Planning Board – Monday, November 26, 2018, 6:30PM
City Hall Council Chambers – 3 Washington Street, 2nd floor
AGENDA

STAFF REPORT

SPR-08-16 MODIFICATION #1 – 31 WASHINGTON STREET AND 41 SPRING STREET – SITE PLAN – WASHINGTON PARK APARTMENTS

Above: Runoff and erosion/sedimentation control areas of concern (circled in red).

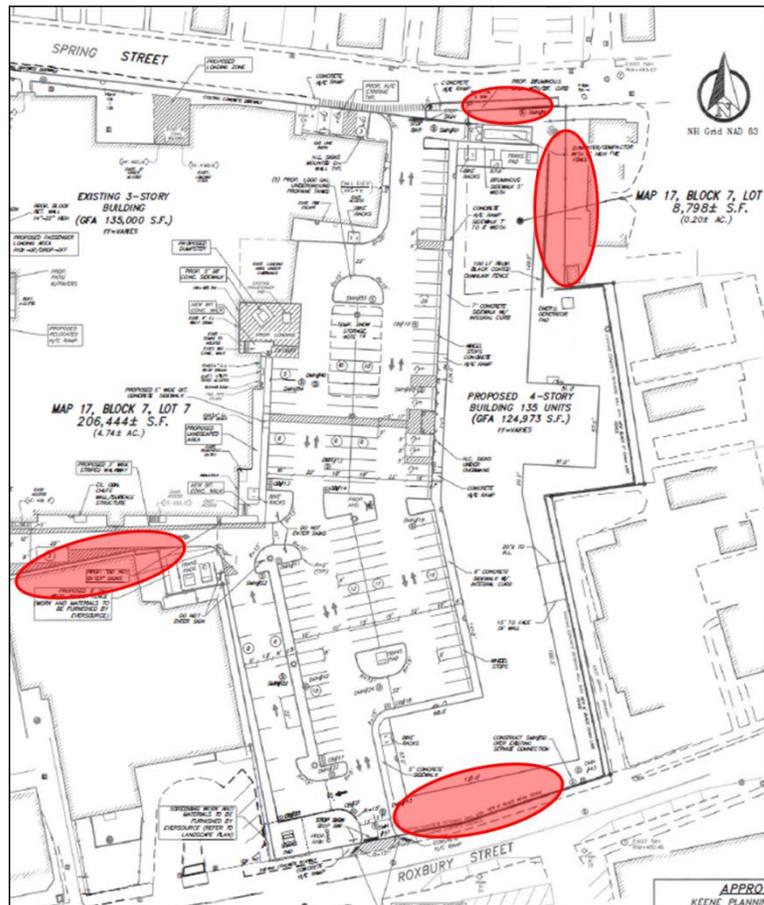
During the course of construction, there have been several documented issues with stormwater runoff exiting the site onto public and private property, as well as sedimentation and erosion control measures that did not function properly during storm events. Some of these issues stemmed from changes that were made to the site which were inconsistent with the approved plan along the northeast boundary of the site adjacent to the property at 47 Spring Street. In the site plan approved by the Planning Board, this portion of the site included a 4 foot high “Redi Rock” retaining wall located approximately 6-8 feet from the edge of the building. The existing slope, which was ~3:1 and vegetated with mature trees and shrubs, was to remain unaltered as screening for the abutting property.

While the 4-foot retaining wall was installed, the applicant later removed the existing trees, shrubs, and other vegetation on the existing slope and

Runoff and sedimentation/erosion issues on Spring St. Photos taken 8/1/18

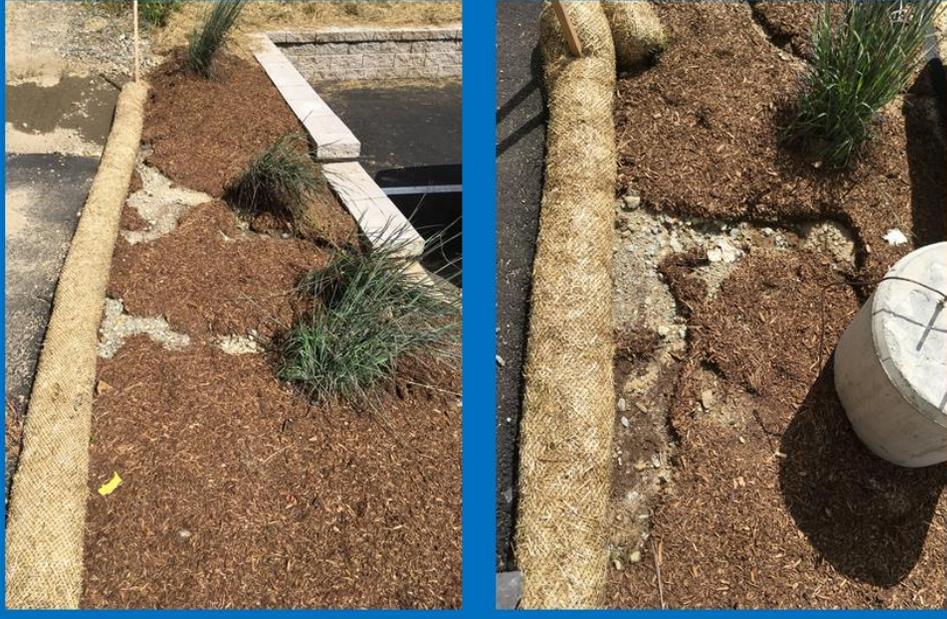
Other areas where stormwater runoff and erosion control have been an issue include the northeast section of the parcel along Spring Street, the south boundary of the parcel along Roxbury Street, and the area of the site south of the former Middle School building along the boundary with the MoCo Arts property. The images below show runoff from these areas of the site during summer rain events.

SITE PLAN
WASHINGTON PARK
MULTIFAMILY HOUSING

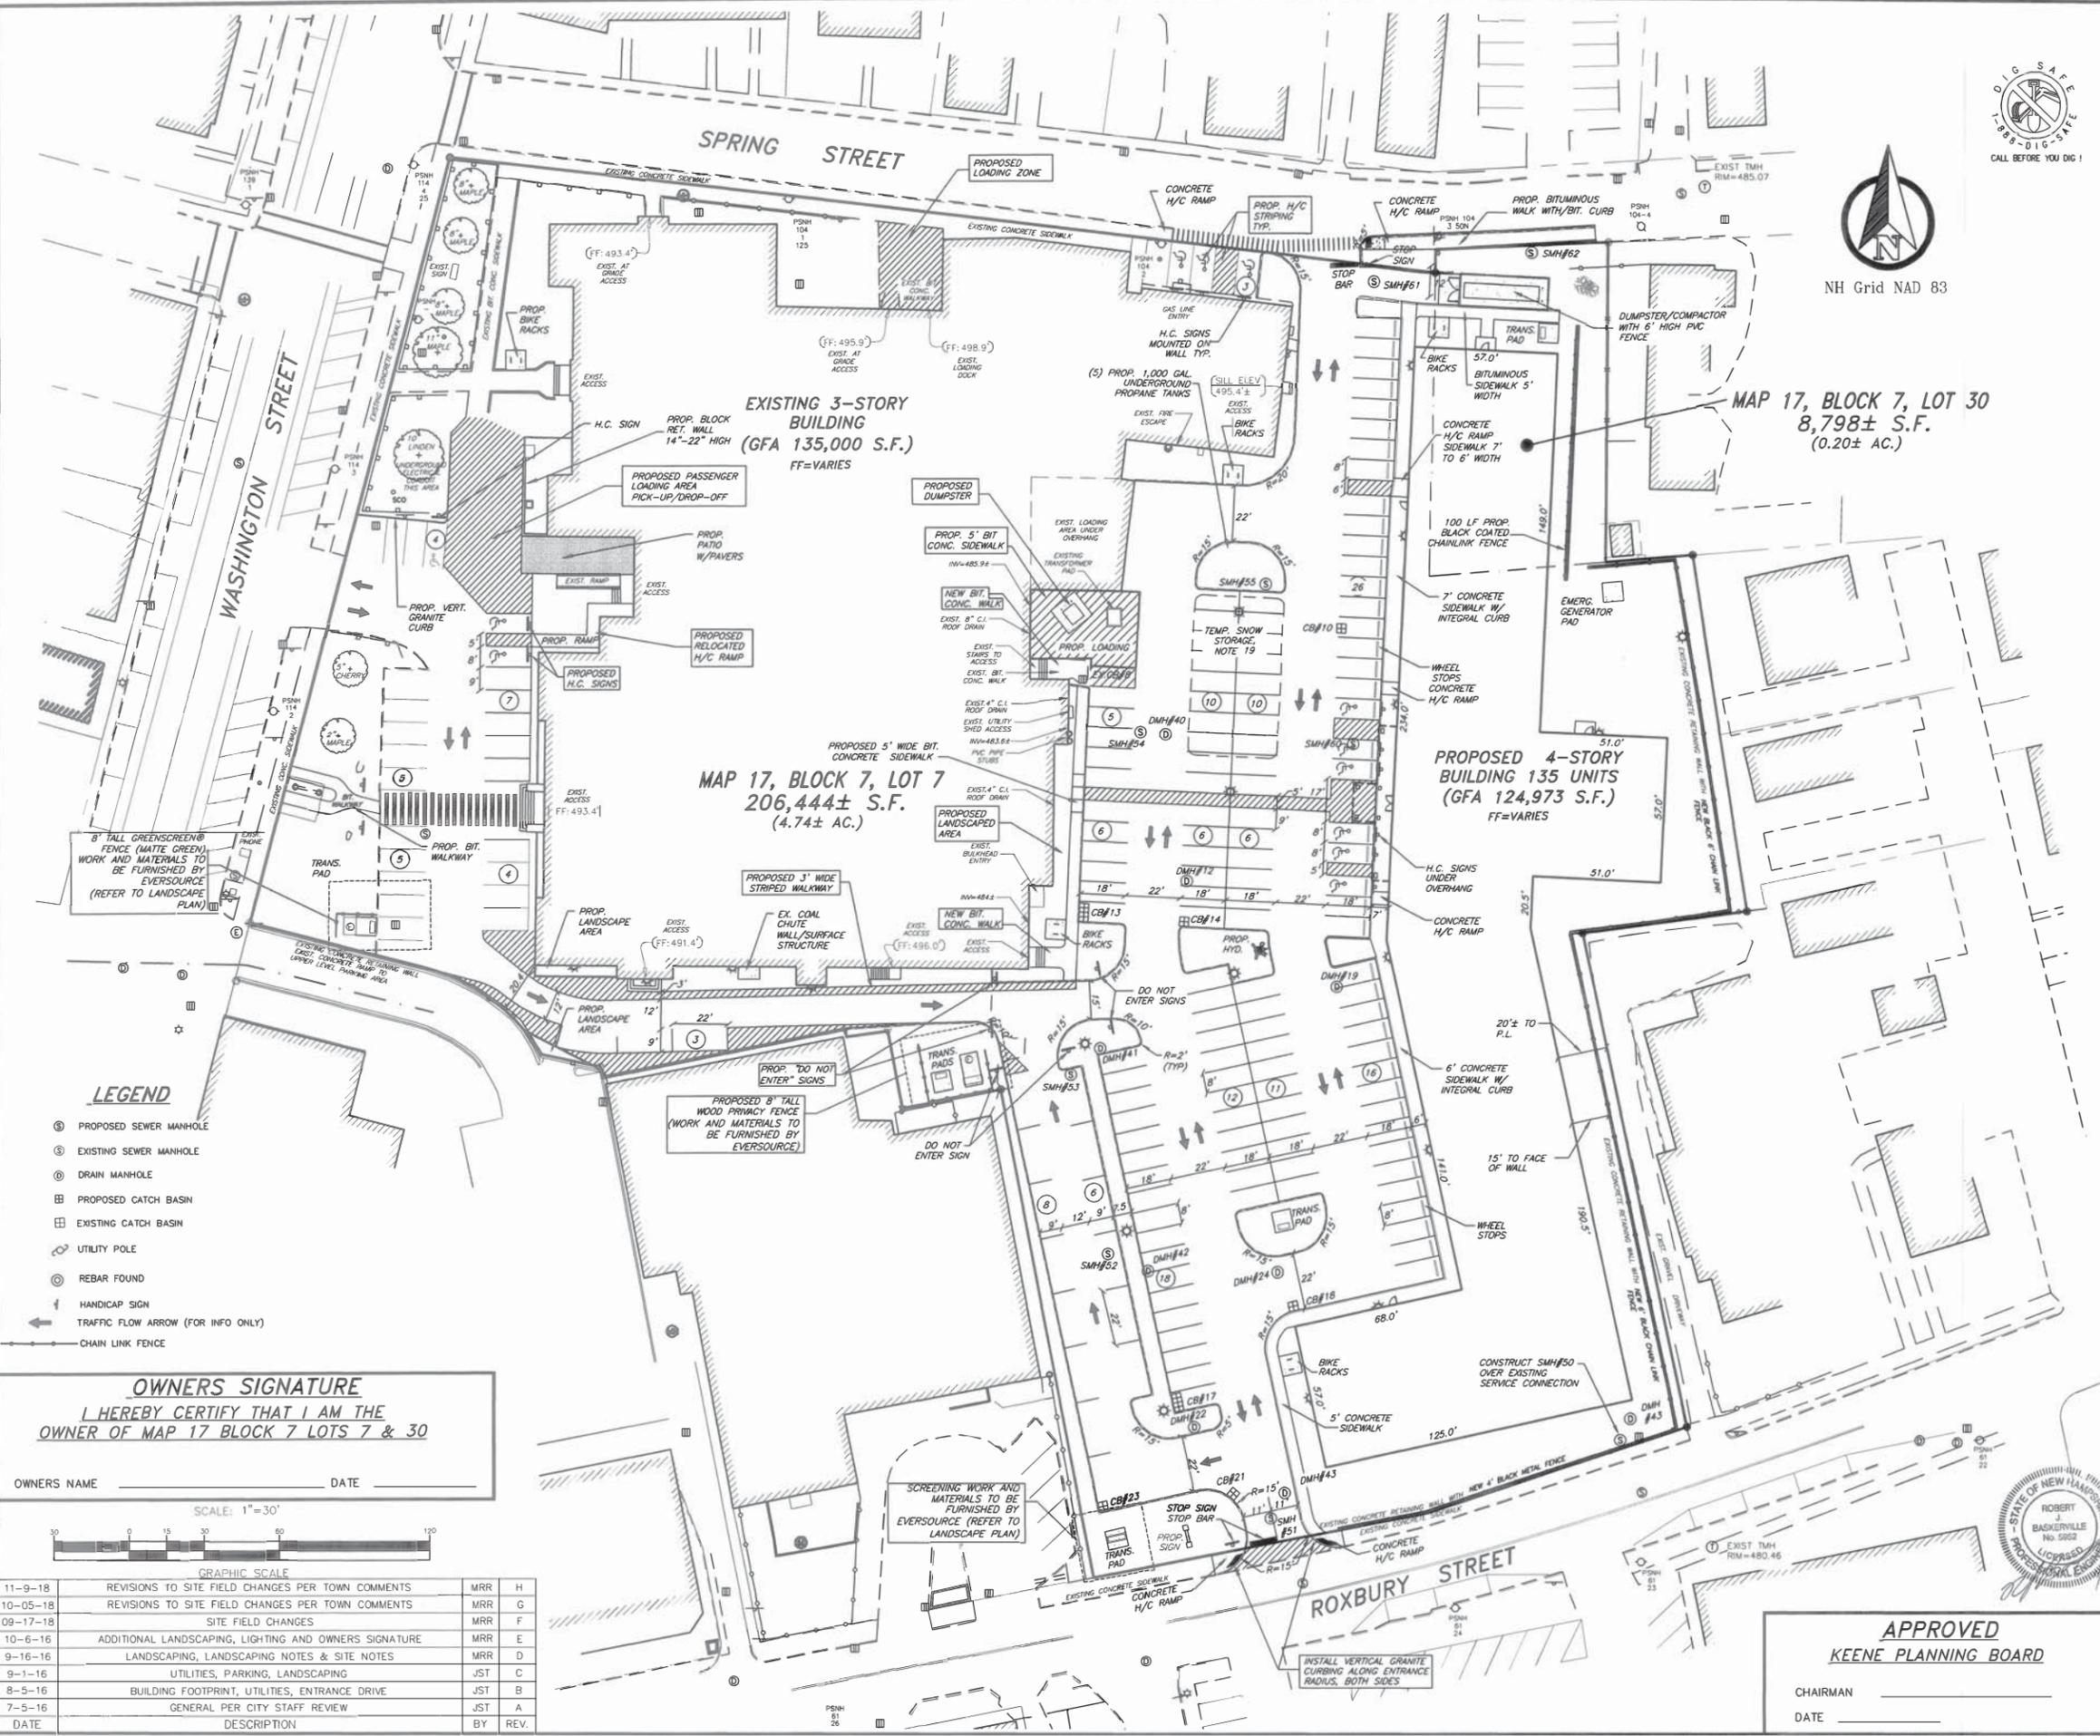
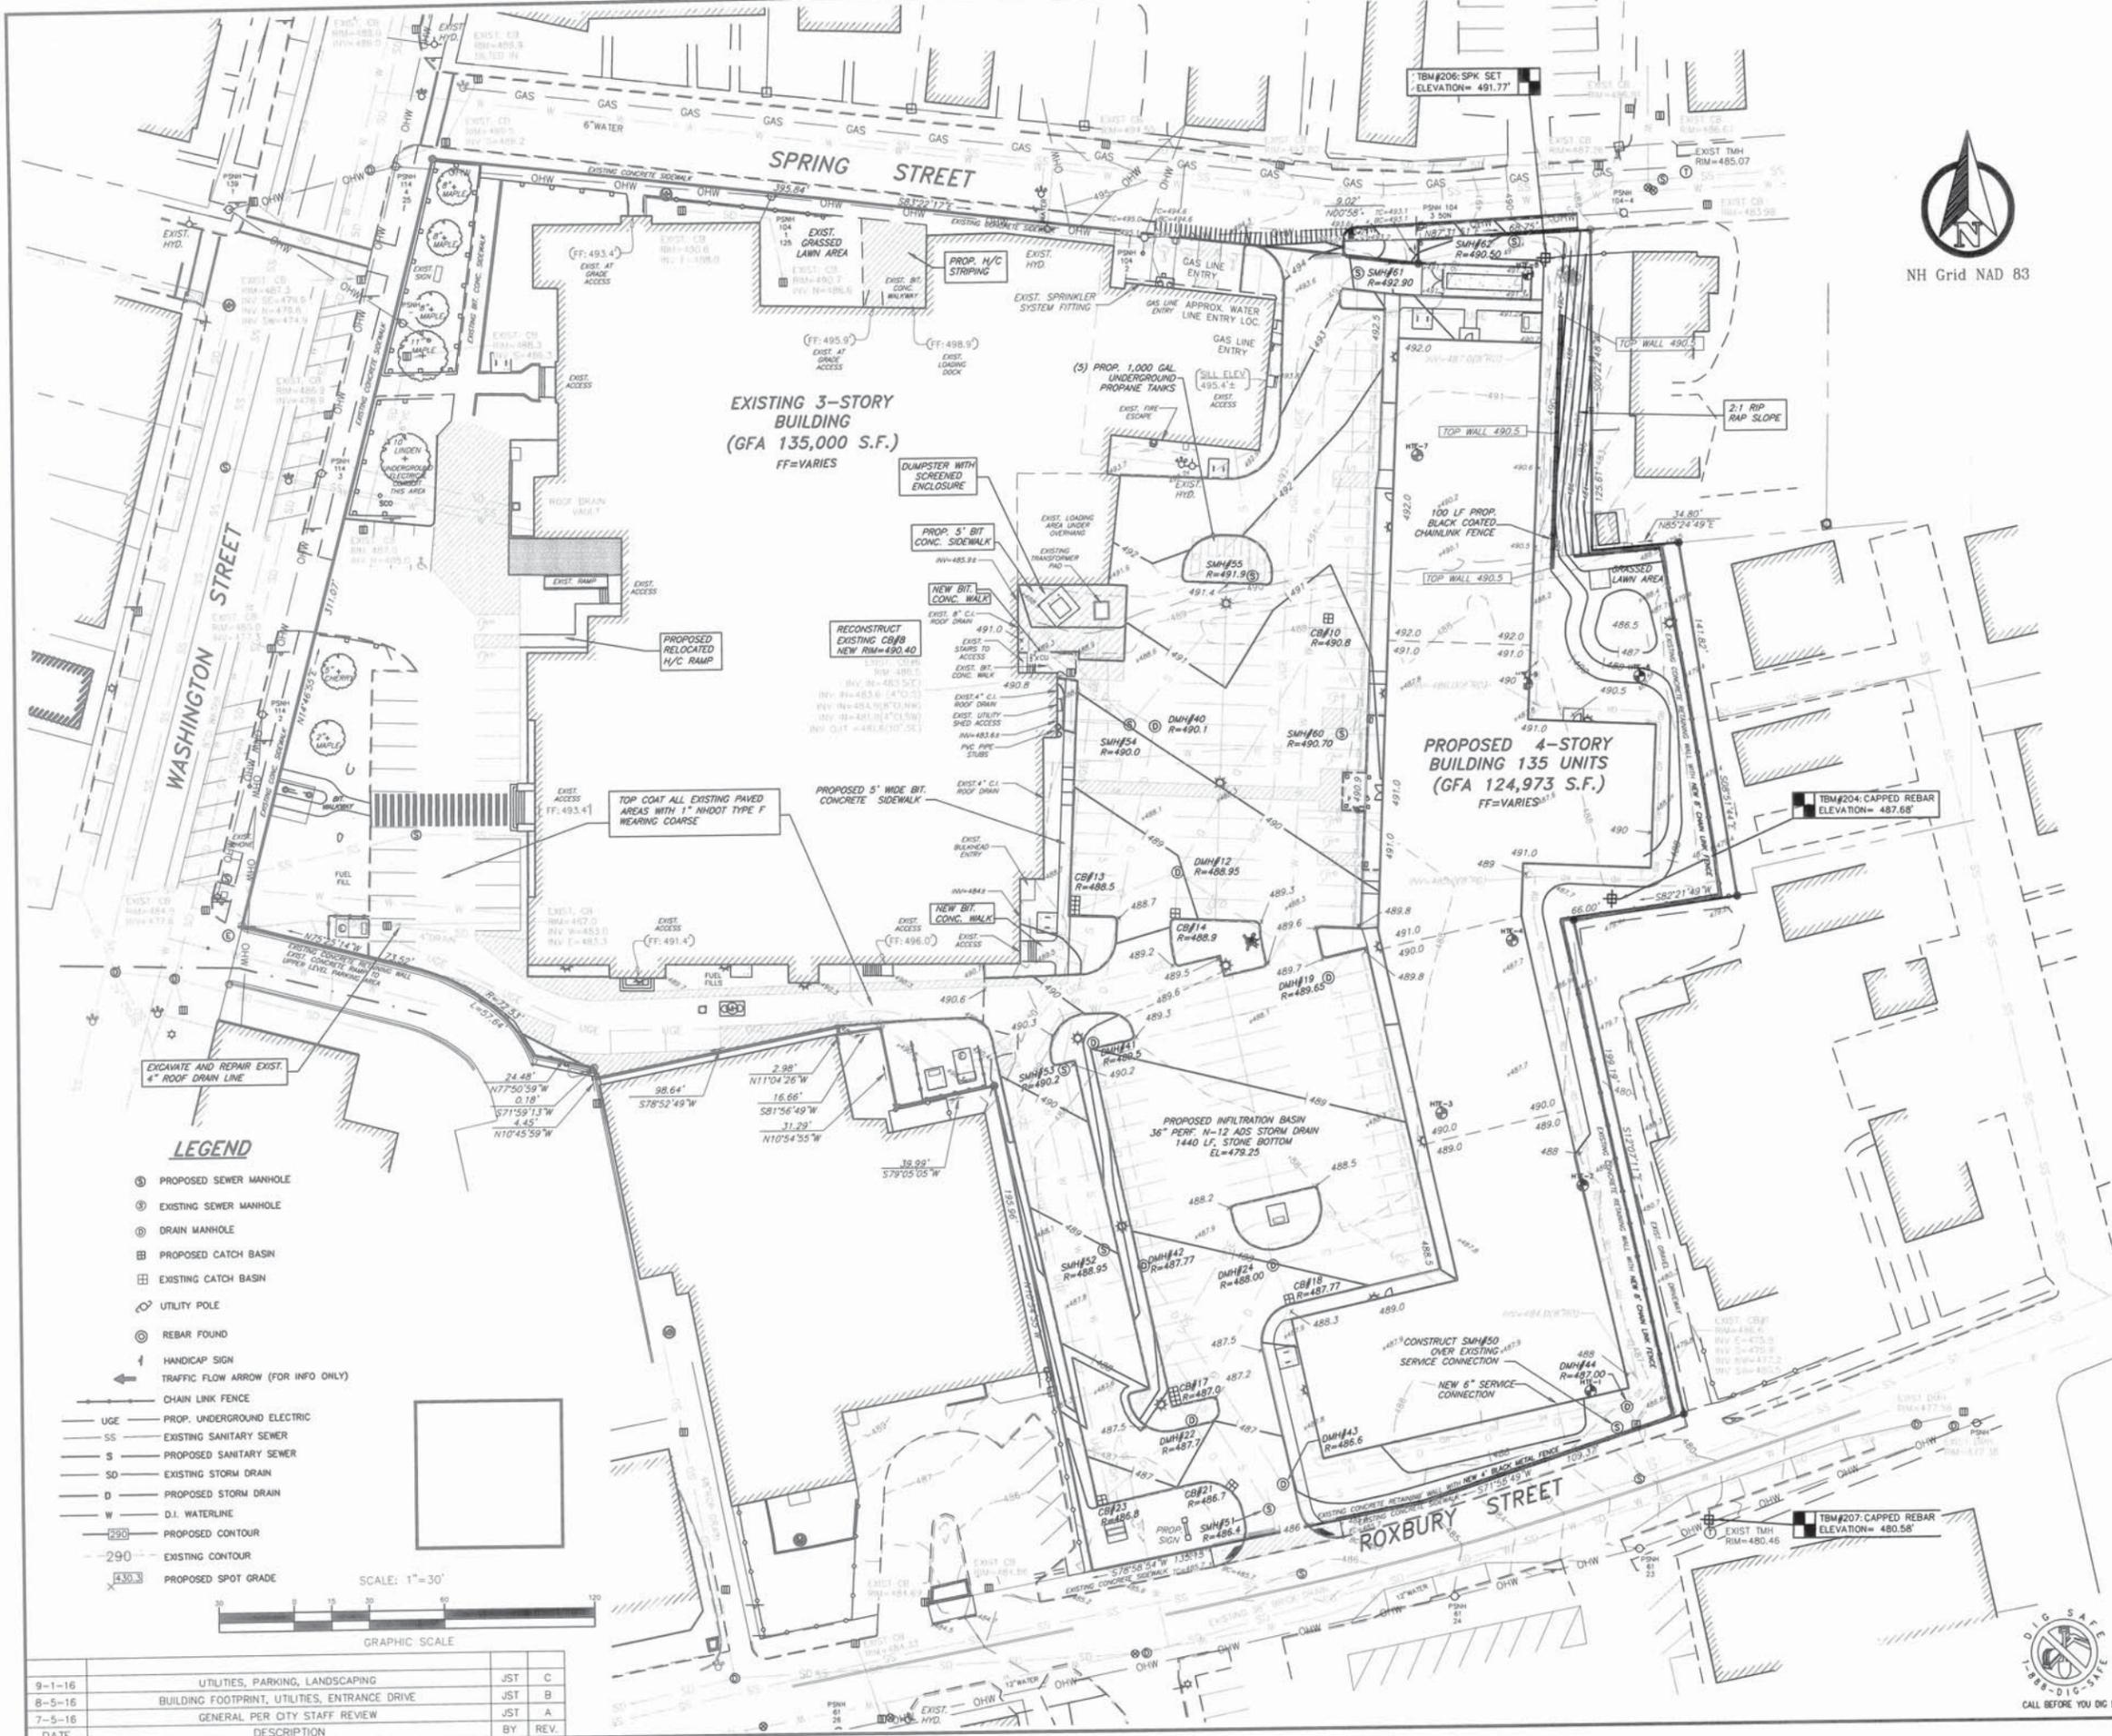
- 2. It is also noted on the new site plan an addition of a generator and LP tank. I have concerns about the location of the generator based on the water collection area, and the ability for the LP tanks to be filled. The distance appears to be over 165 ft. and beyond the filling capability of a delivery truck.*

1. *With regards to the proposed retaining wall, the maximum retained height as shown on the updated plans is 1.5' (+/-). This will not require an engineered design. The developer should submit manufacturer's installation instructions for City records.*
2. *The proposed sidewalk/curbing along Spring Street is acceptable as depicted. Please omit the diagonal striping within the marked "crosswalk". Place 6" white lines connecting each of the proposed accessible ramps.*
3. *As explained in a letter from the City Engineer to Washington Park of Keene, LLC, dated November 1, 2018, the concrete sidewalk along Roxbury Street must be restored and sealed this construction season so that the City may undertake its normal winter maintenance operations.*

1. Drainage: The applicant proposes the following changes to grading, impervious cover, and drainage:
 - The applicant proposes to remove the extra fill that was added to the northeast corner of the site along the boundary with the property located at 47 Spring Street, expose ~1.5-3 feet of the concrete block retaining wall that was installed earlier during construction, and re-grade the existing 2:1 slope to return it to a 3:1 slope. A 100 linear foot black-coated chain link fence would be installed along the top of the retaining wall for safety. The applicant proposes to seed the slope with a slope seed mix containing seeds for grasses, shrubs, and trees that would naturally grow in over time.

- The applicant proposes to install an emergency generator and concrete pad behind the apartment building along the eastern edge of the site, near a depression intended for water storage and infiltration. The applicant has noted that the generator and pad, which is about 8 feet by 8 feet in size, would be located in a flat area and would not be located in the depression. The Fire Department has noted concerns about this generator location, which is located too far away for a tank to be refilled by a delivery truck. The Board may wish to question the applicant about how the generator will be powered.
